Village of Arlington Heights
Plan Commission
Board Room
Arlington Heights Village Hall
33 S. Arlington Heights Road
Arlington Heights, IL 60005
December 13, 2017
7:30 PM

- A. St. James Parish - 831 N. Arlington Heights Rd. - PC#17-012
Planned Unit Development, Amendment to Special use Ordinances
#63-078, #97-078, #07-012, Amendment to the Comprehensive Plan,
Plat of Subdivision, Variations

**CHURCH ADDITION
AND RENOVATION**
831 N. ARLINGTON HEIGHTS ROAD
ARLINGTON HEIGHTS, ILLINOIS 60004

SITE PLAN

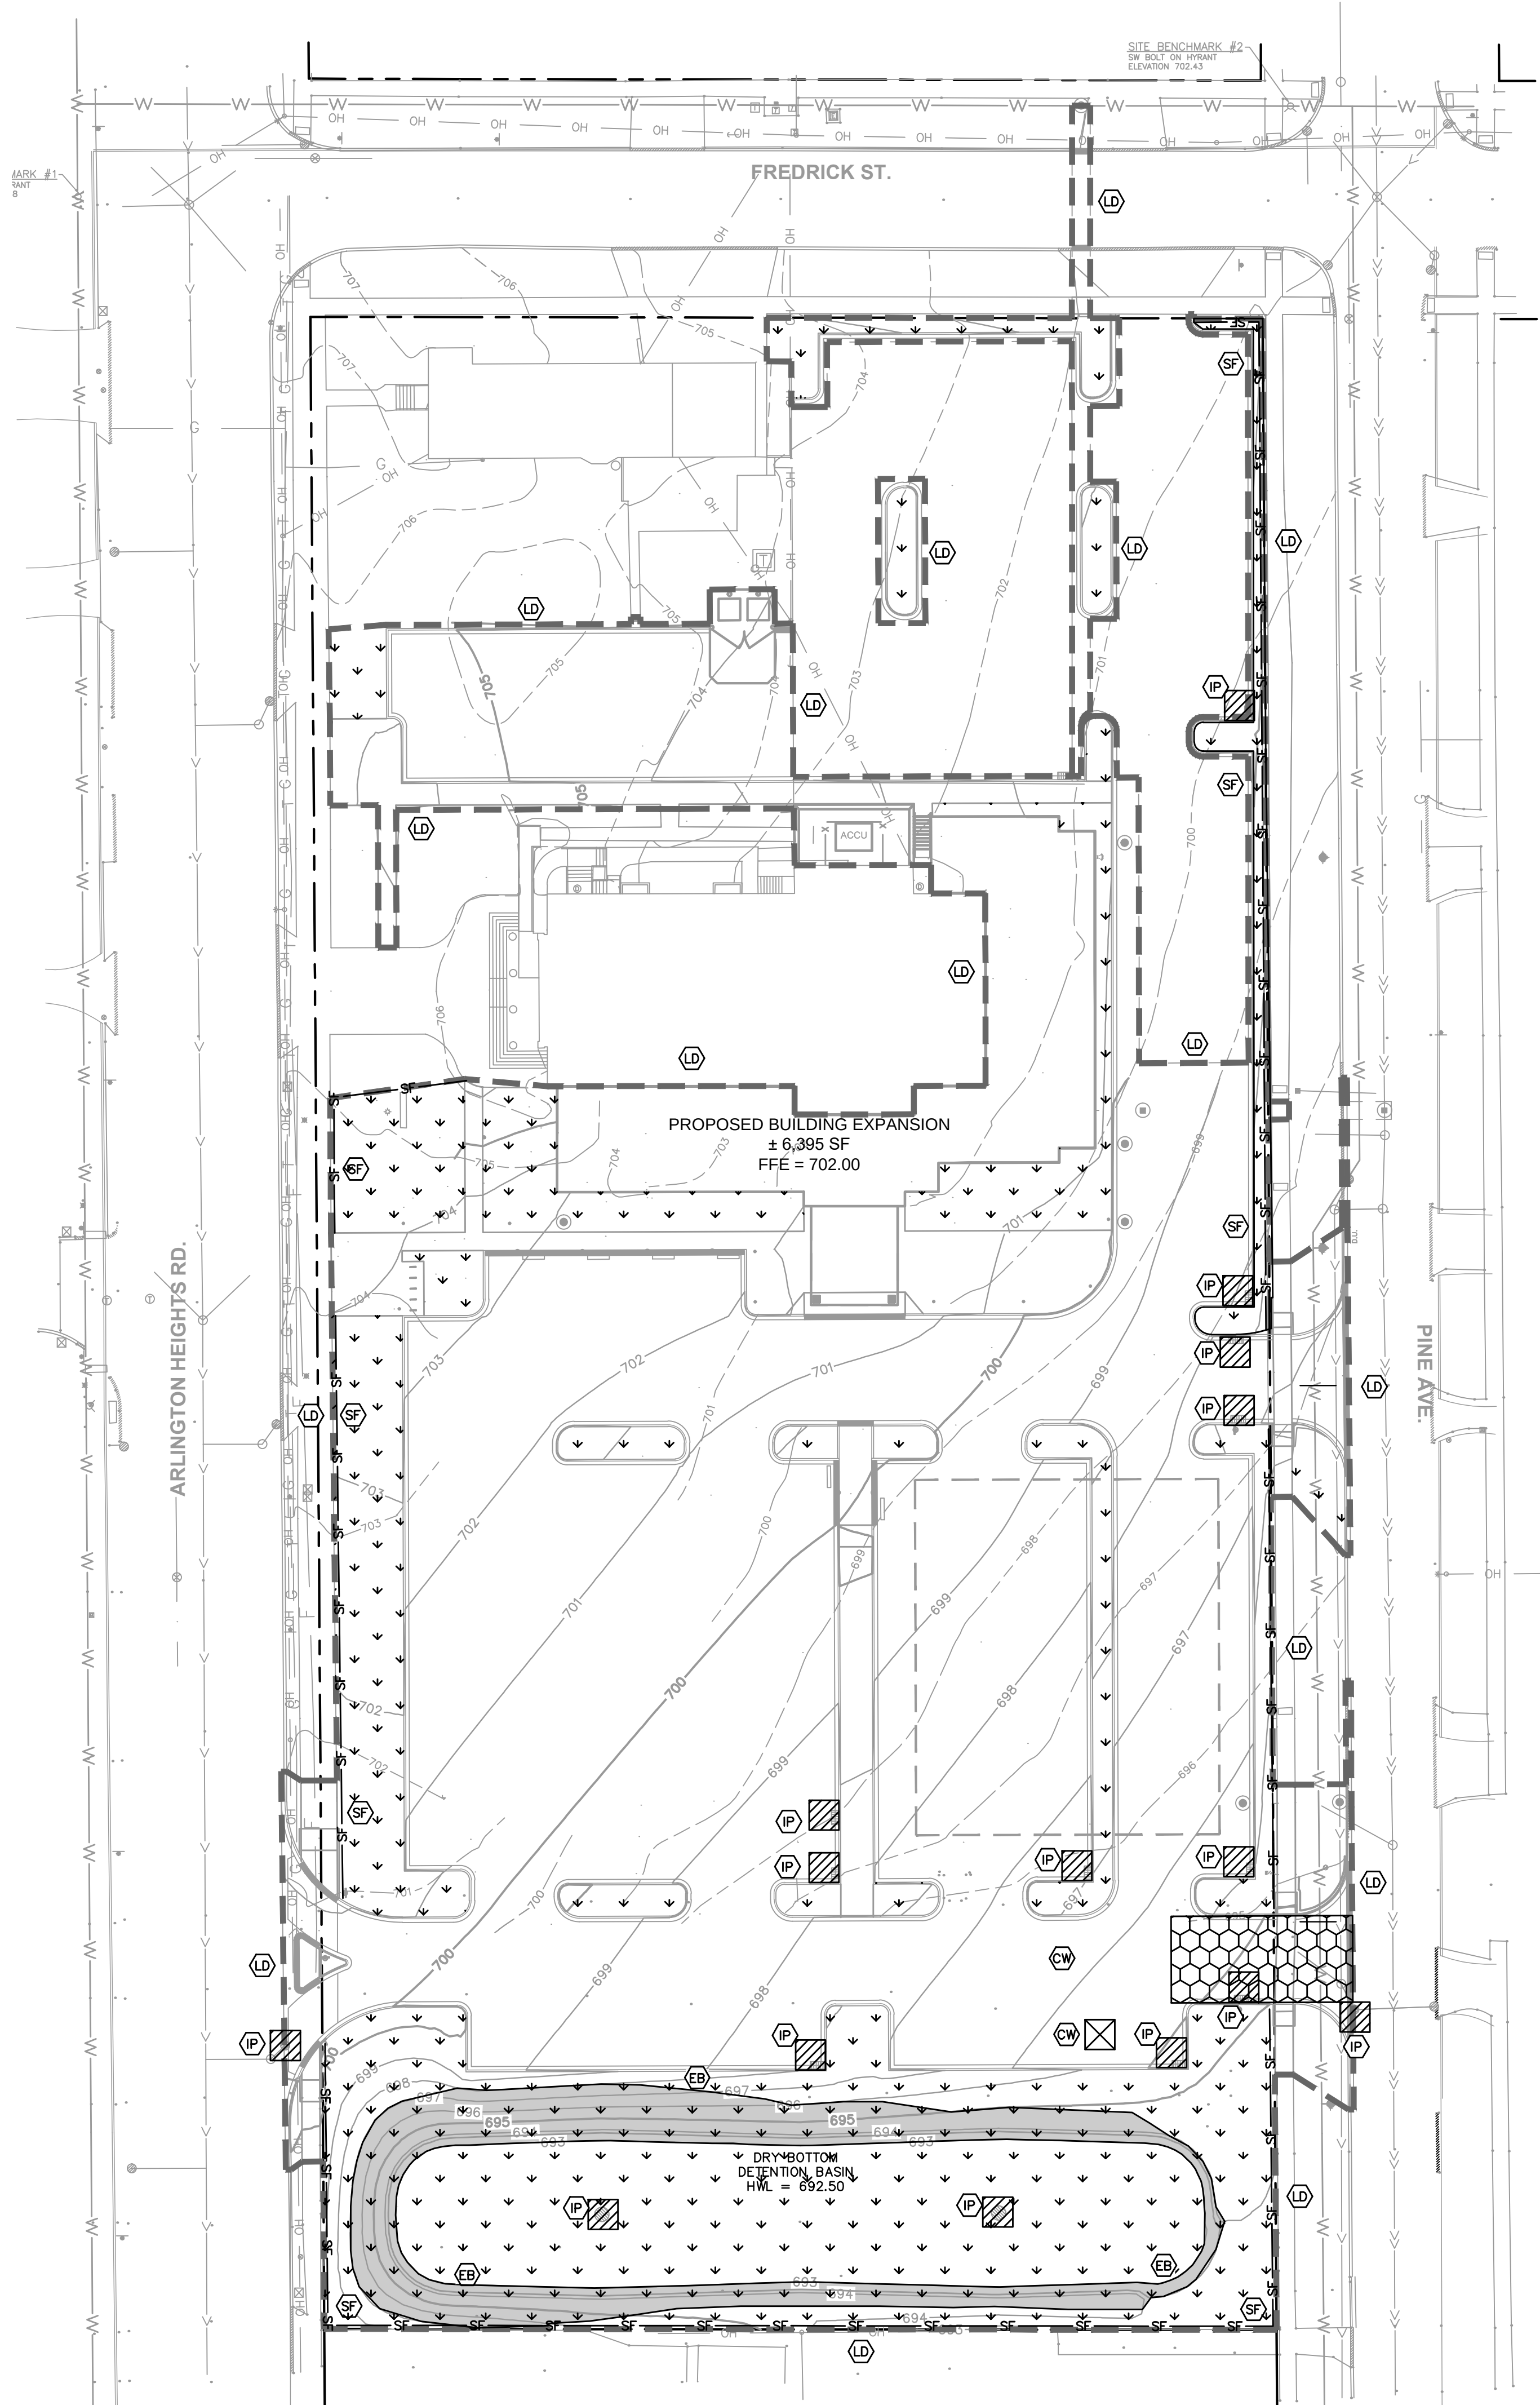
54. Sheet C3.0: At the RIRO driveway on Arlington Heights Road, the public sidewalk shall take precedence over the curb and shall be continuous through the driveway with the curbs stopping on either side of the sidewalk. This comment can be addressed at final engineering.

55. Sheet C3.0: All utility open cuts on Village streets will require heavy duty pavement as replacement. This comment can be addressed at final engineering.

56. Sheet C3.0: It is suggested additional private driveway and public sidewalk removal and replacement be shown on the north side of Frederick Street to account for the impact associated with the installation of the 5' diameter valve vault. This comment can be addressed at final engineering.

Response: The plans have been revised to show the public sidewalk sections being carried through the driveways. Curbs will not be constructed through the public sidewalks. ADA panels will be installed at all drives with stop control. See Sheet C3.0.

Response: Depressed curb and gutters have been added along the Pine Street drives. The curb returns have been reduced to 15'. See Sheet C3.0.

Response: All sidewalks adjacent to parking stalls have been widened to 6.5' width. This allows a 5' wide sidewalk width if a parked car has a 1.5' overhang. See sheet C3.0.

**HEAVY DUTY
ASPHALTIC PAVEMENT SECTION**
N.T.S.

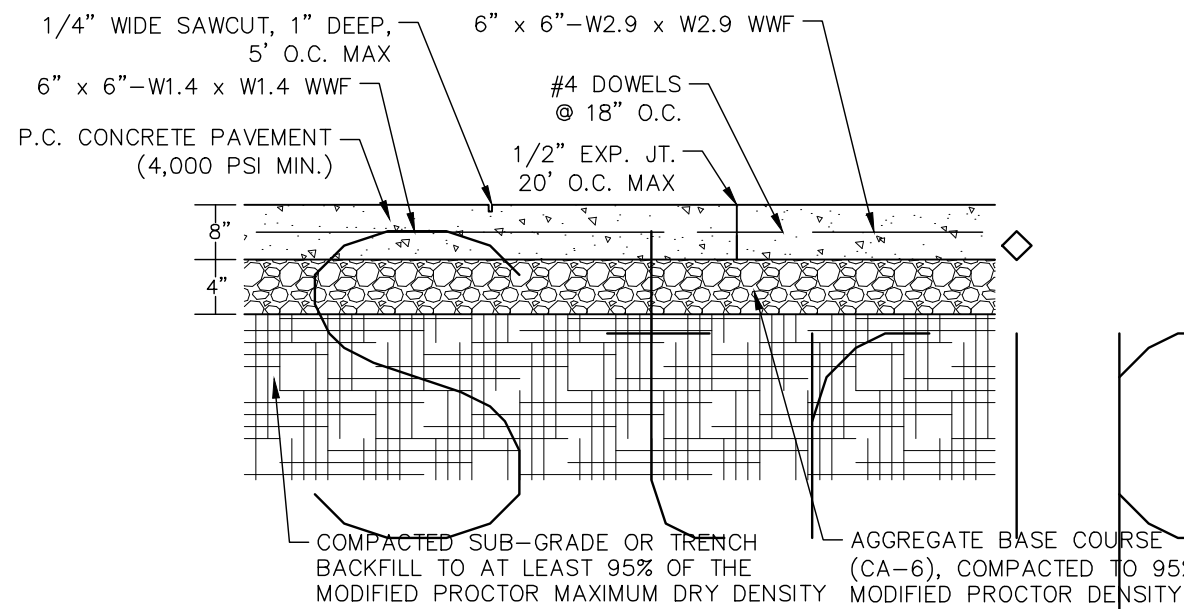
57. Sheet C7.0: The pavement thicknesses for the heavy duty pavement section must conform to the following: 2" Surface, 2-1/4" N-50 Binder, 5" N-30 Binder, and 4" CA-6 Stone Subbase. This comment can be addressed at final engineering.

Response: The heavy duty asphalt pavement section has been revised to meet the required materials and thicknesses. The concrete sidewalk detail has been revised to specify an 8" thickness in the driveway aprons and public sidewalks. See Sheet 7.0.
